# ADDENDUM NO. 2

February 23, 2024

Yorktown High School – Addition and Renovations 1100 South Tiger Drive Yorktown, IN, 47396

# TO: ALL BIDDERS OF RECORD

A103

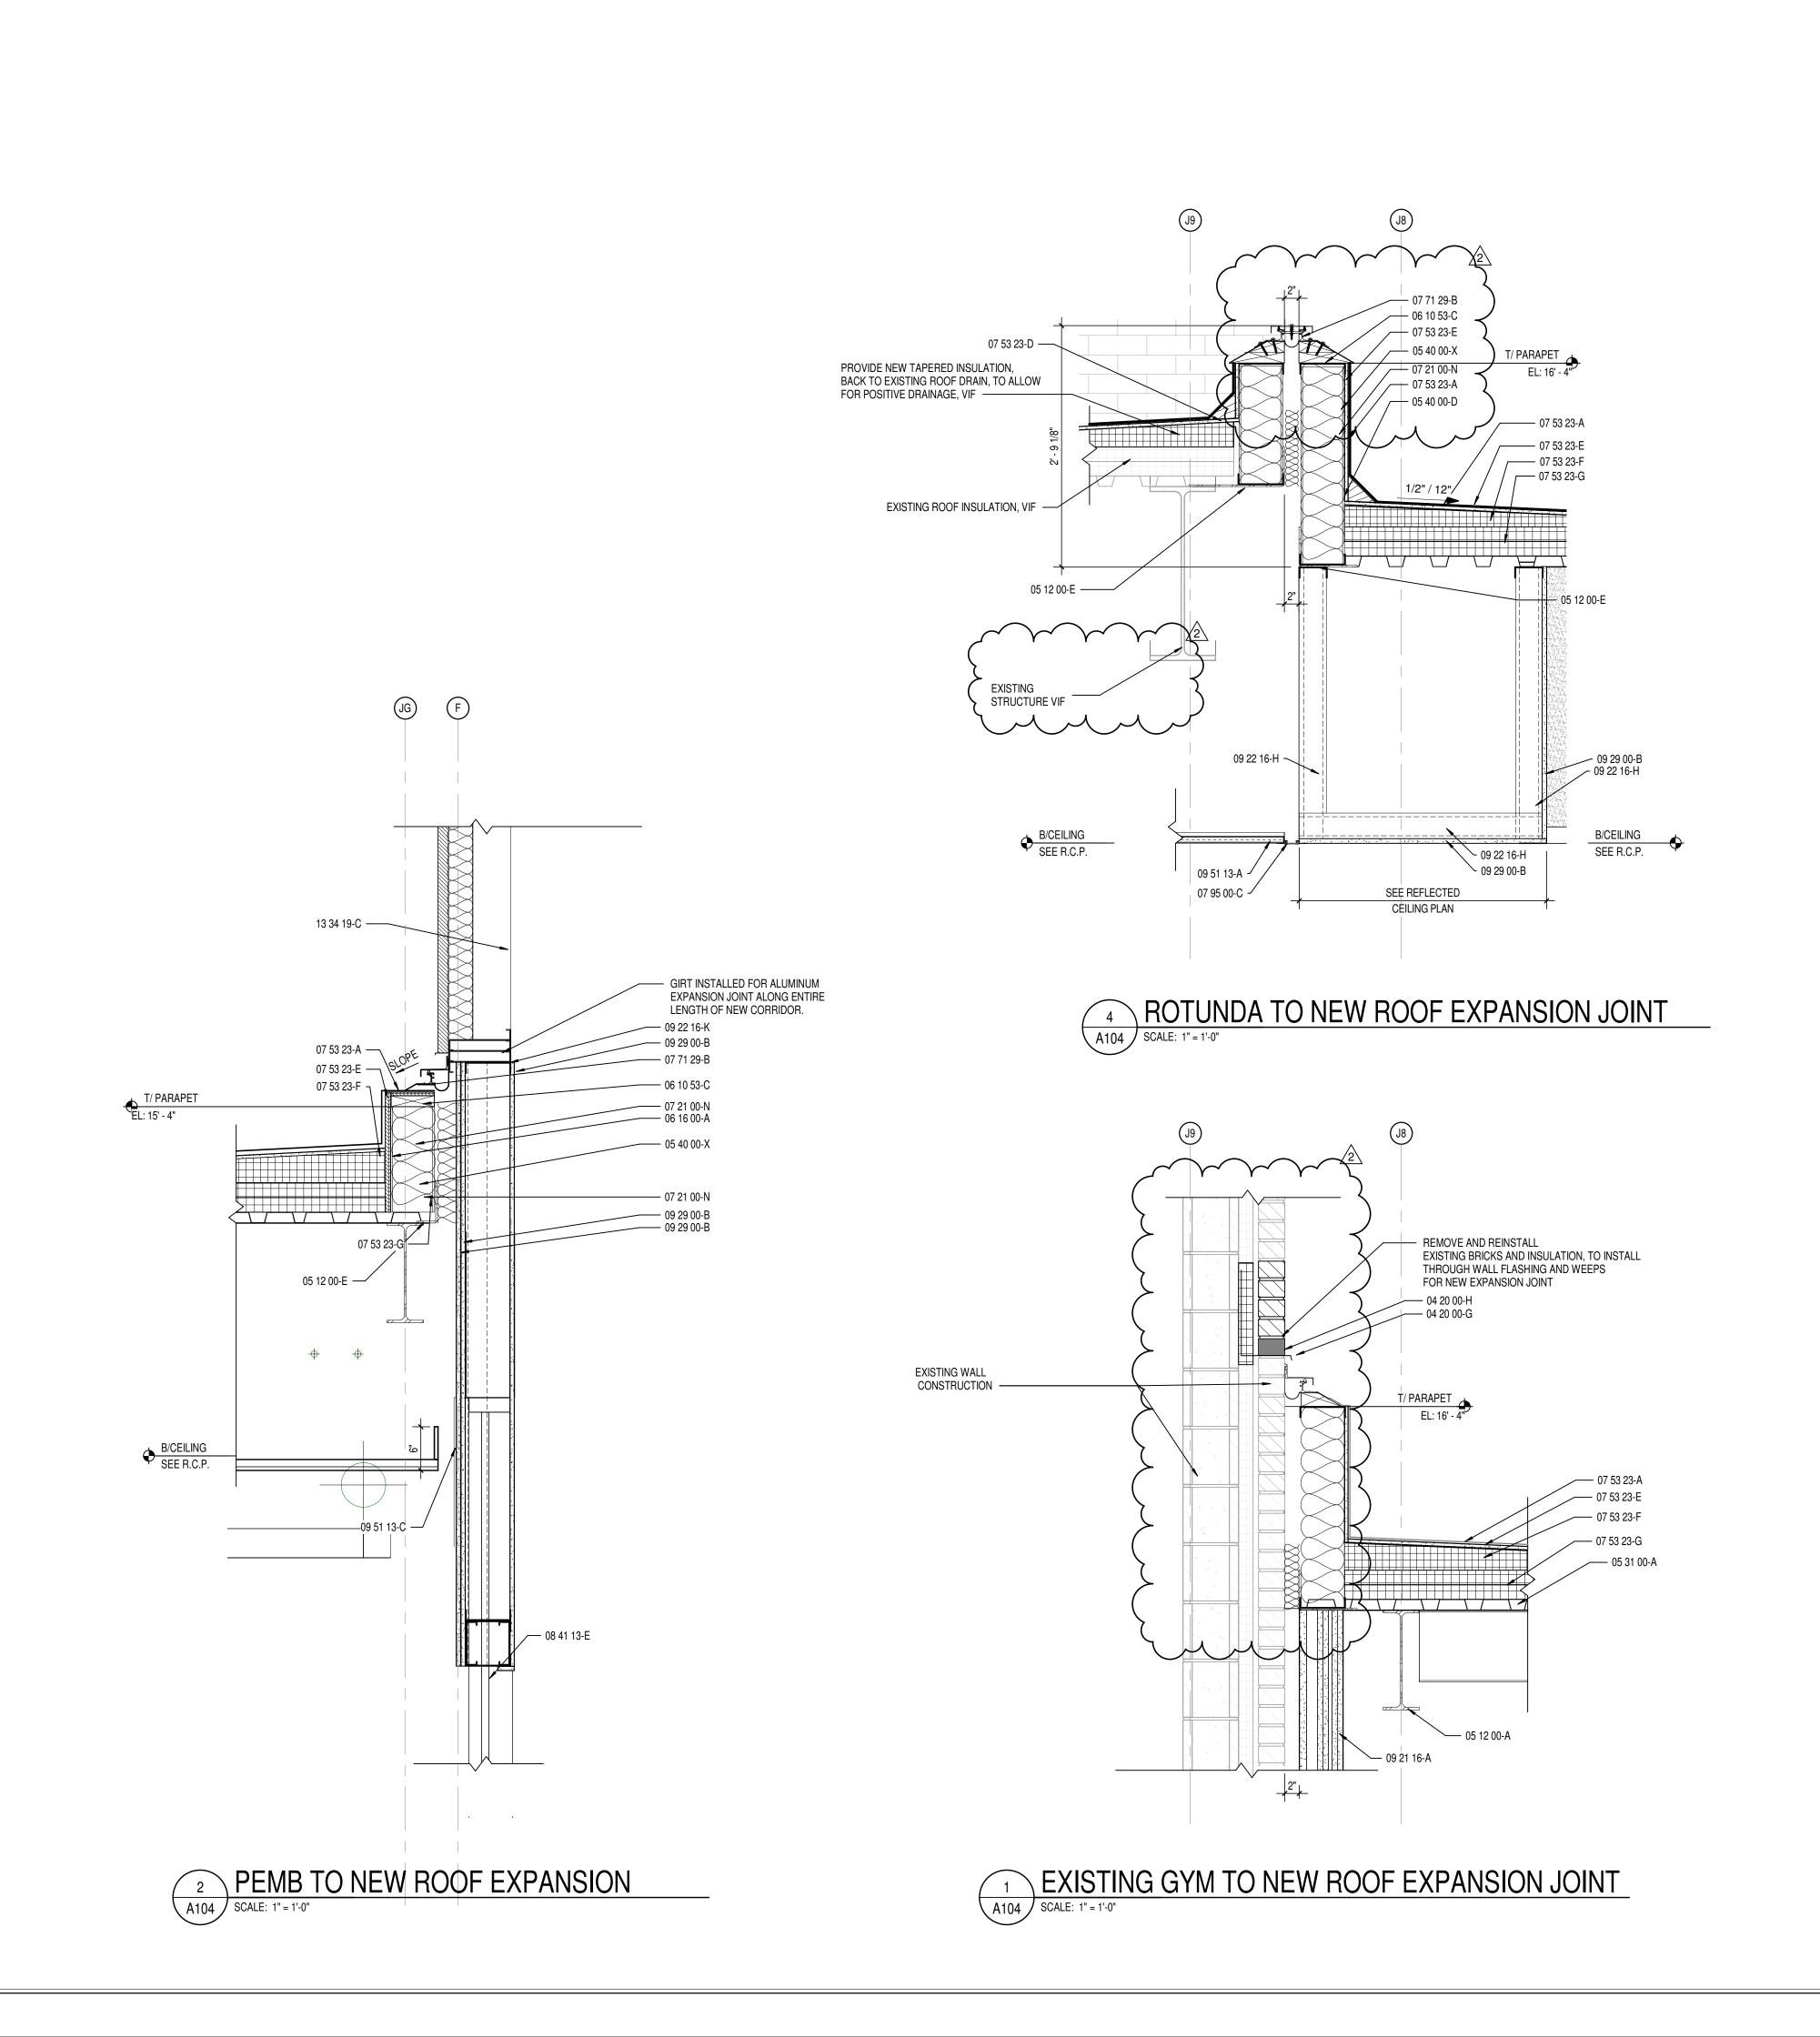
A. Modified roof plan clarity.

DRAWING NUMBER A104

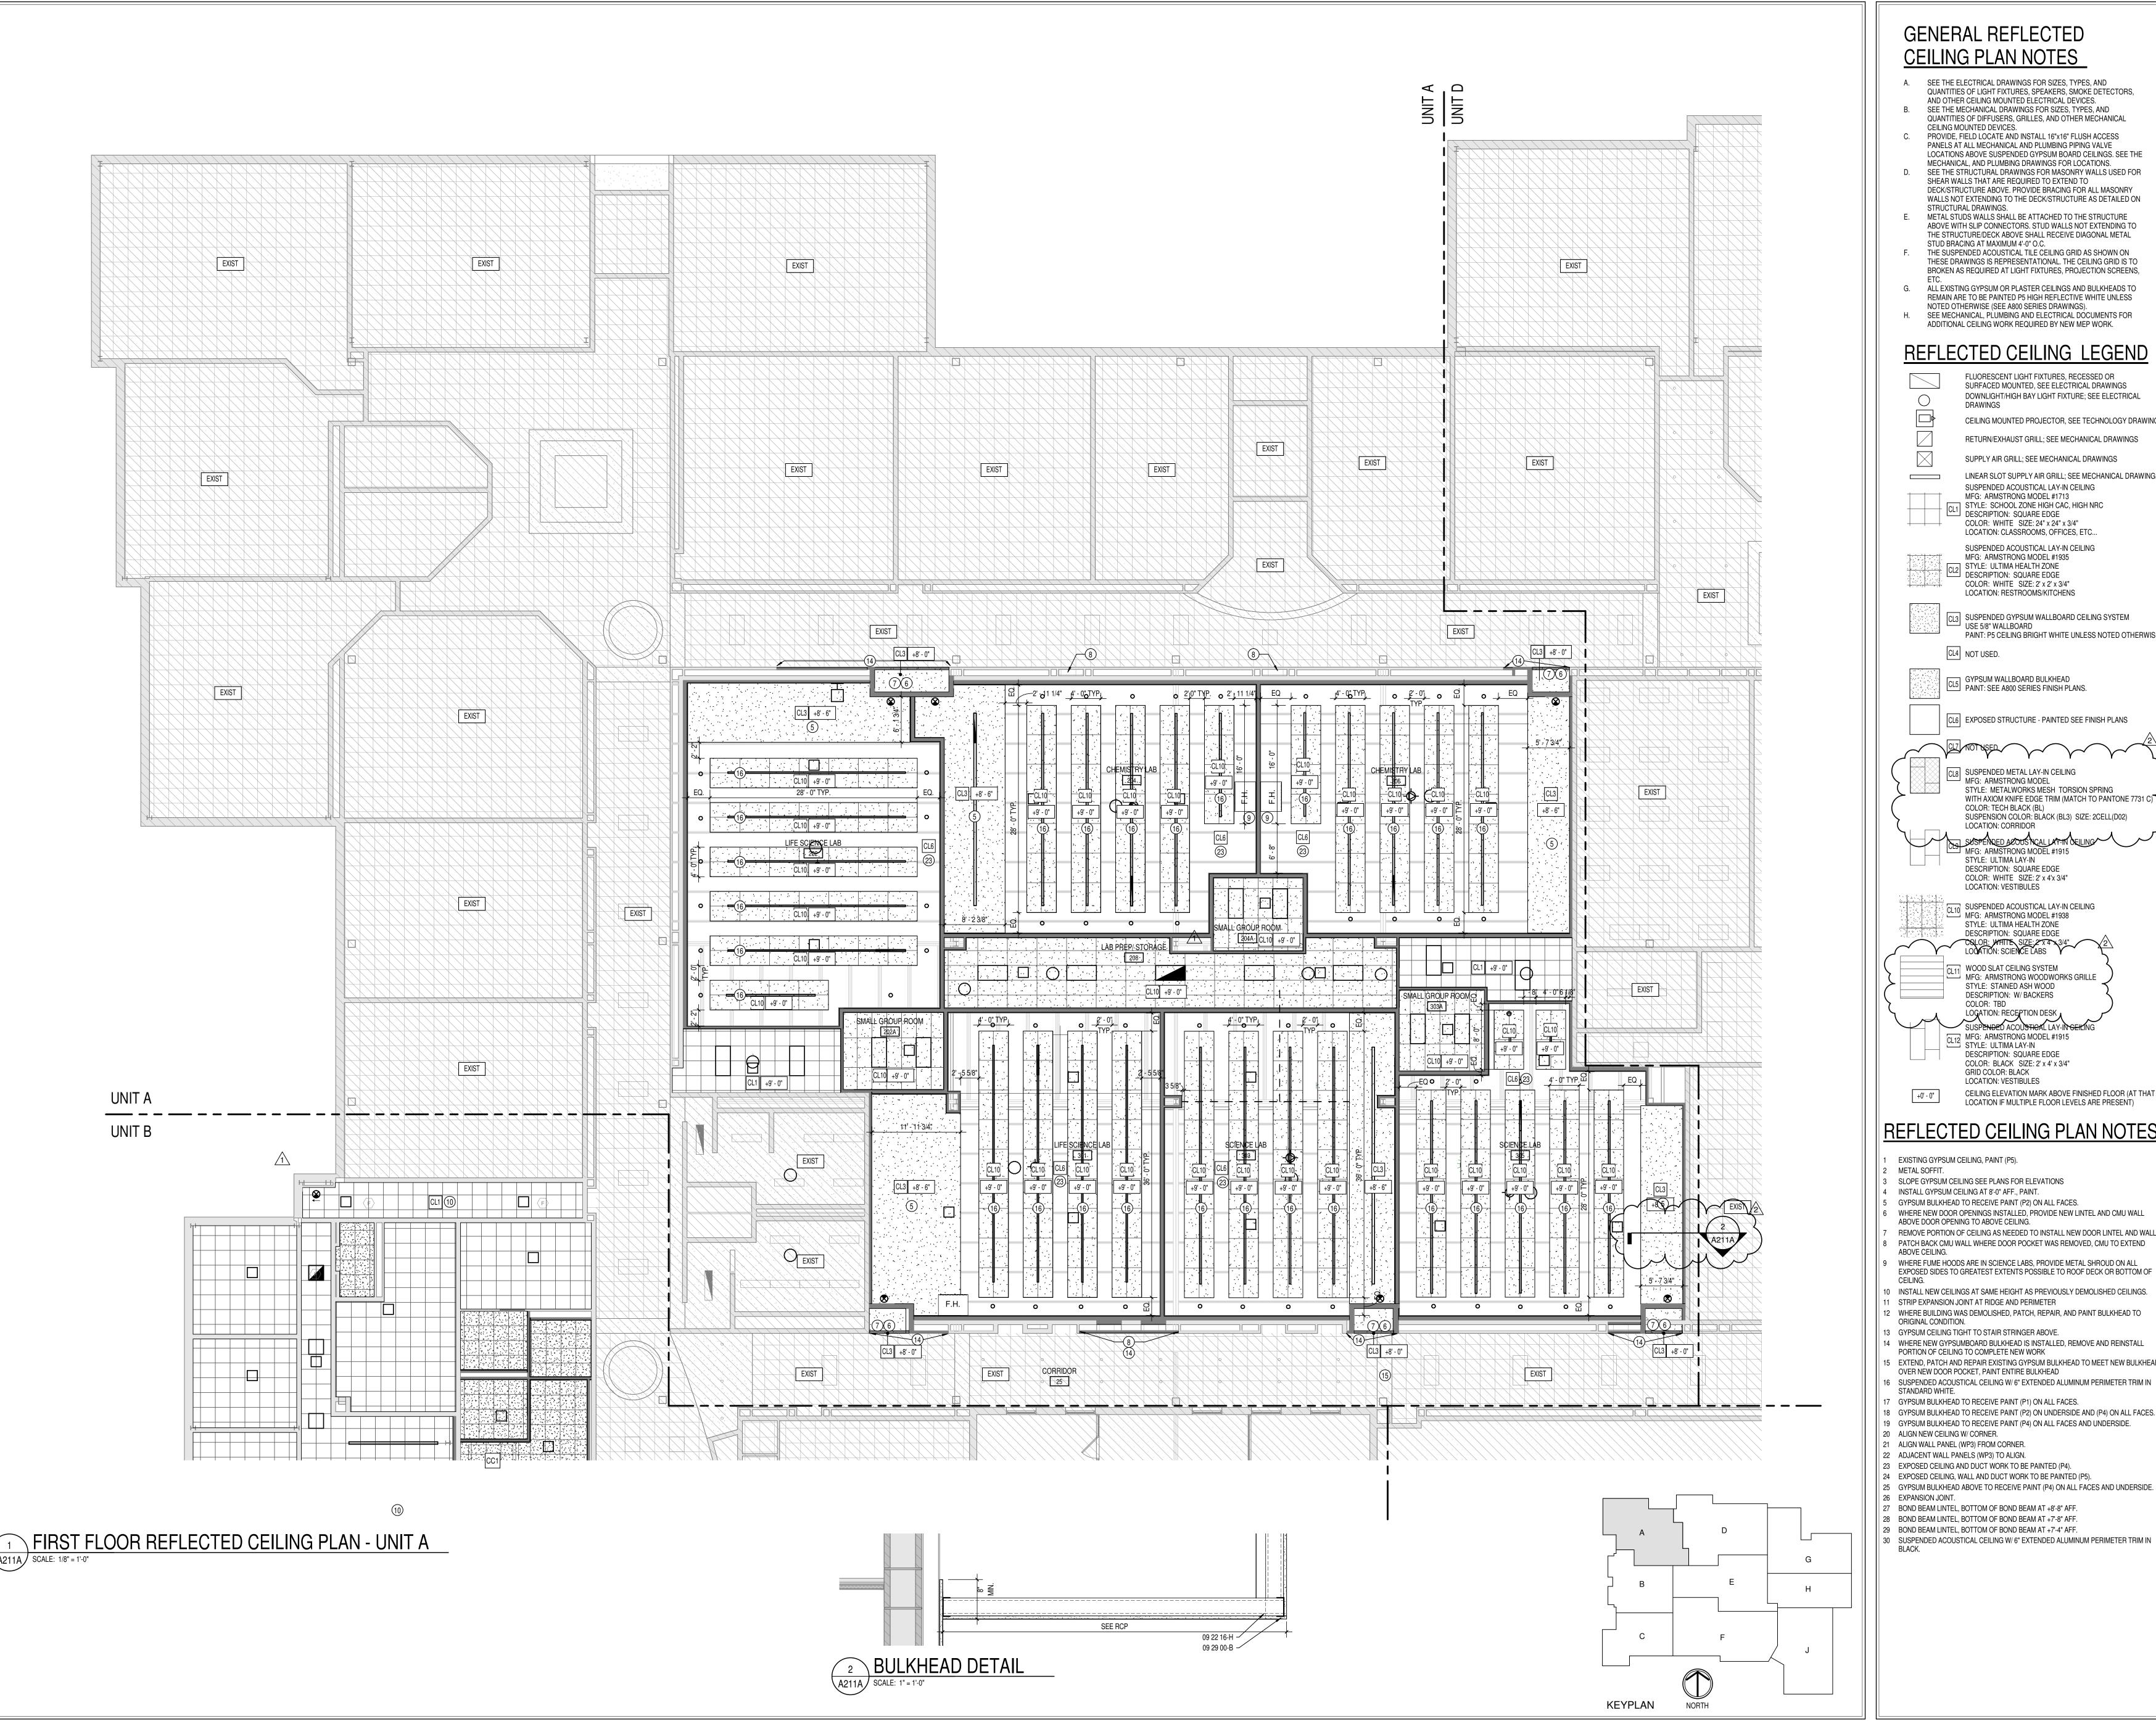
A. Modified roof parapet details 1/104, 3/A104, and 4/A104

A400

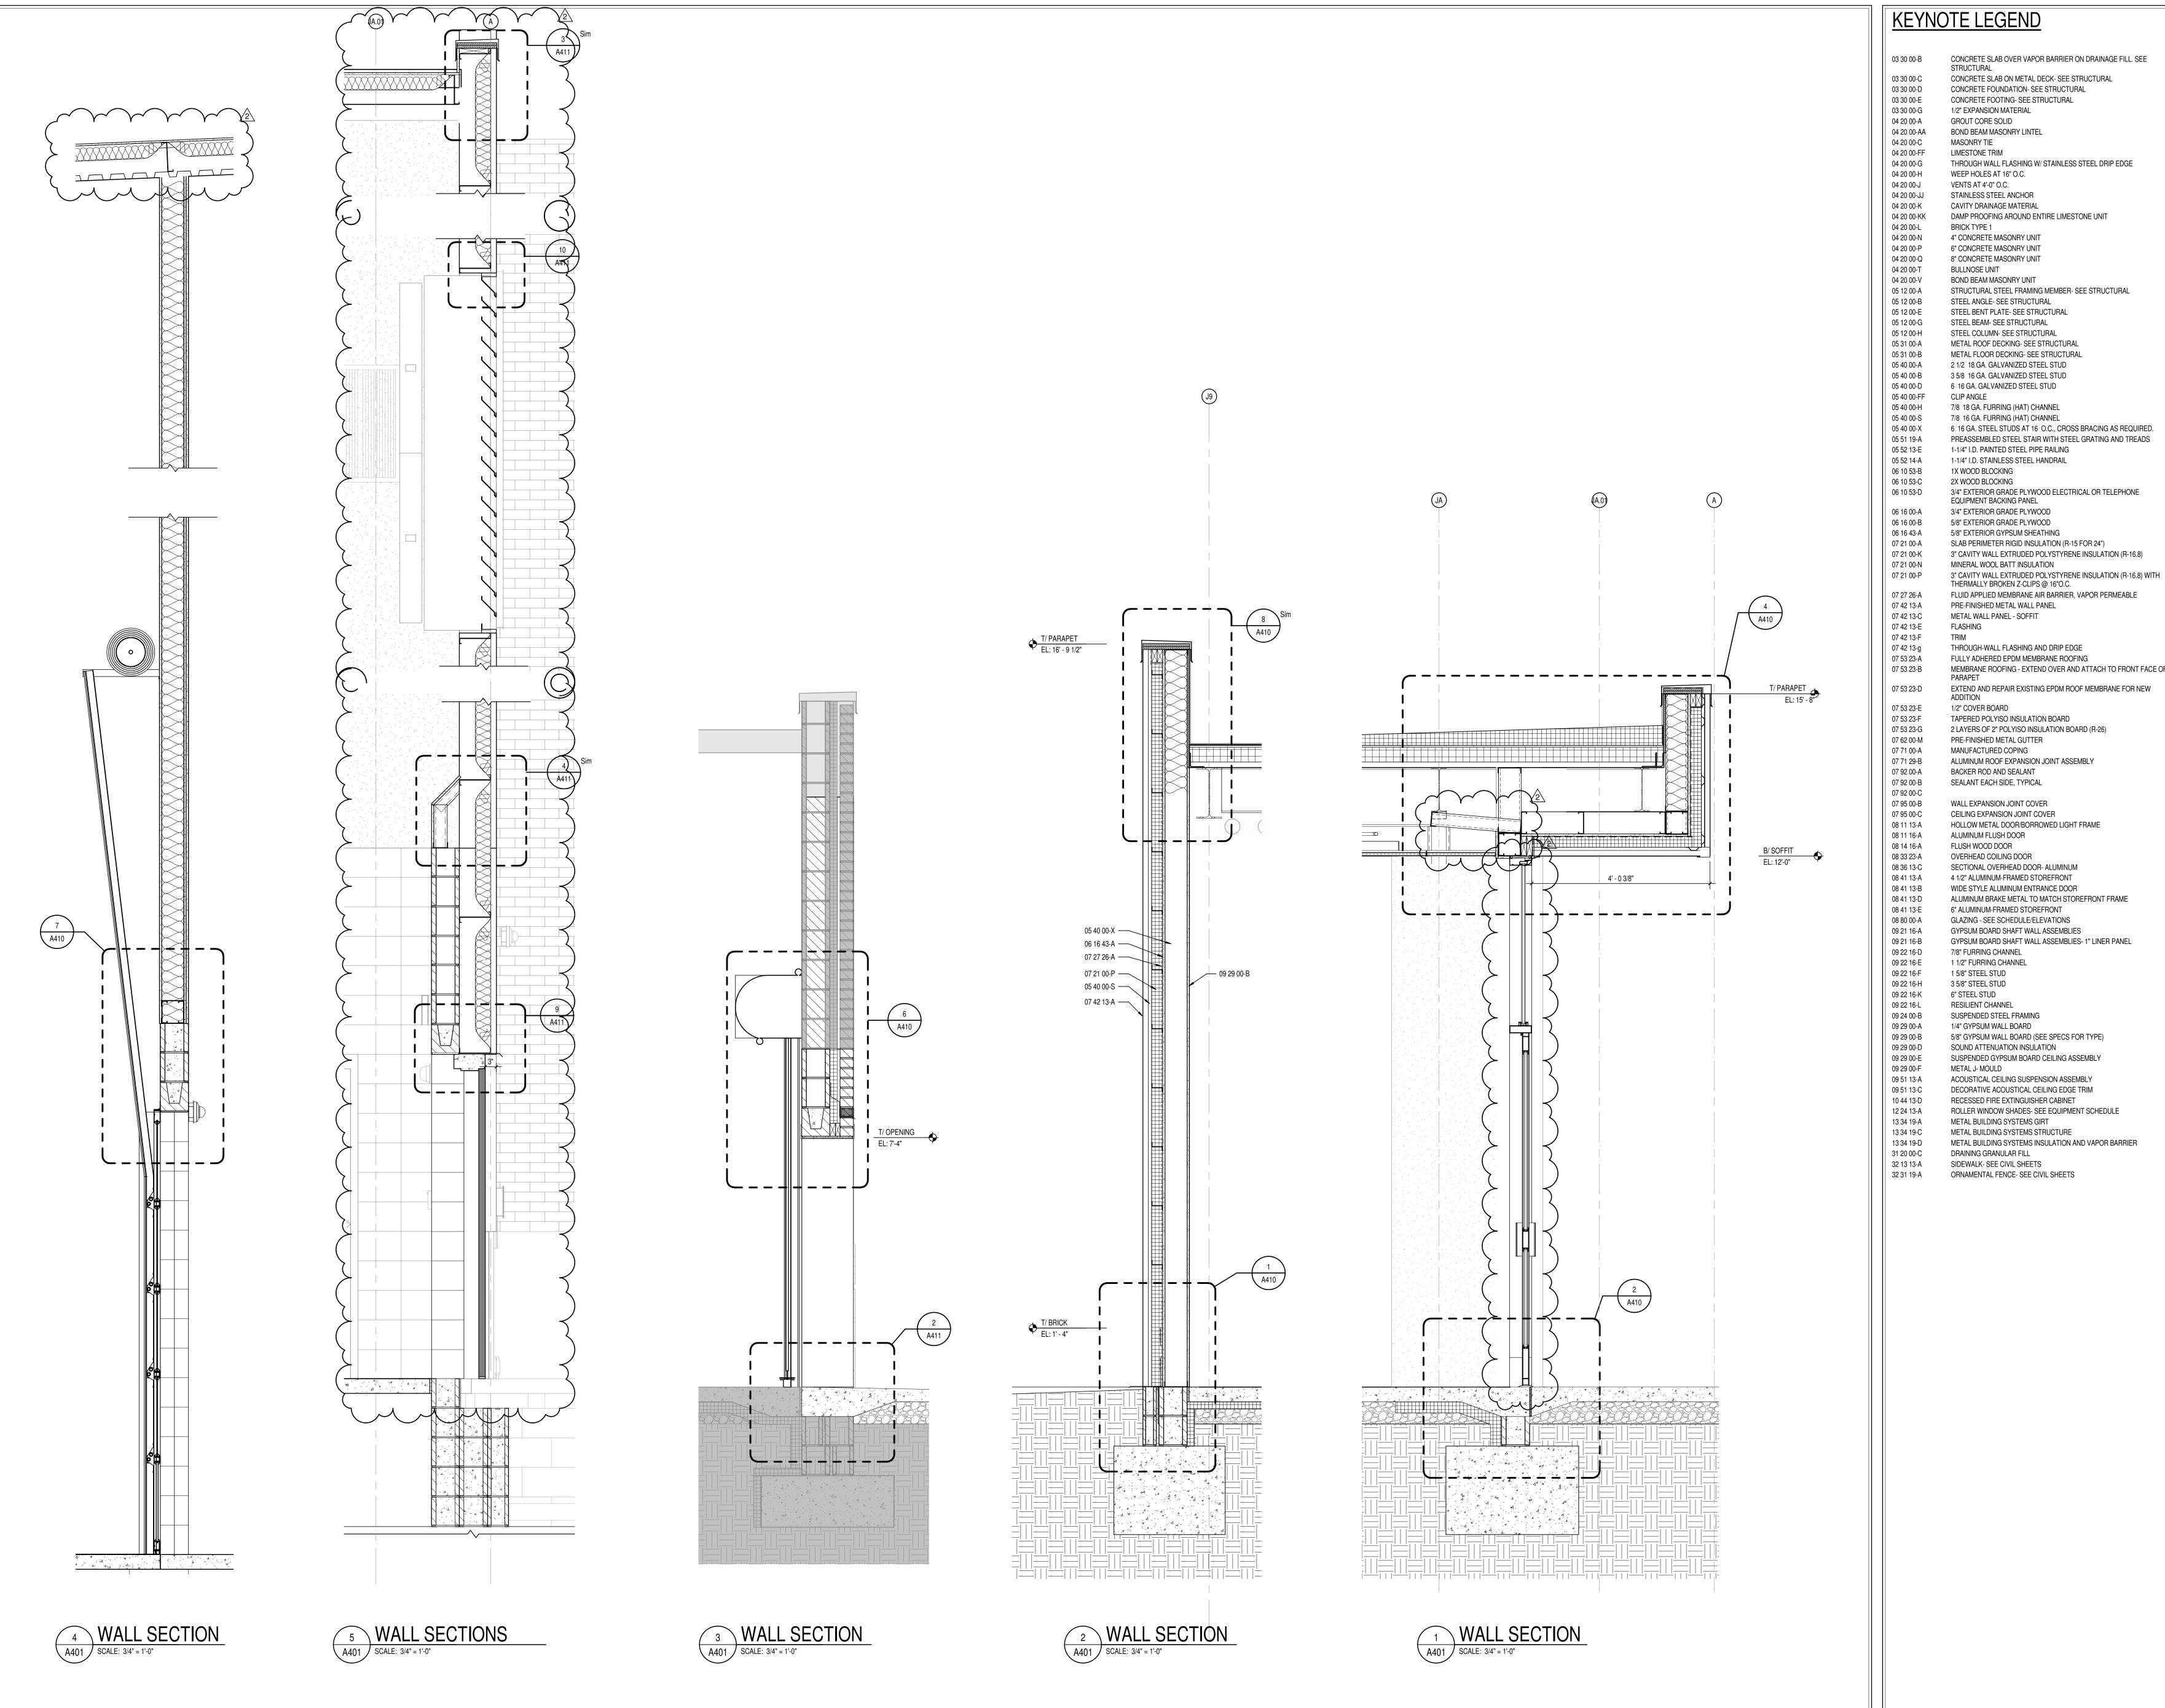
- A. Revised details on 4/A400 due to shift.
- B. Added keynote to 2/A400
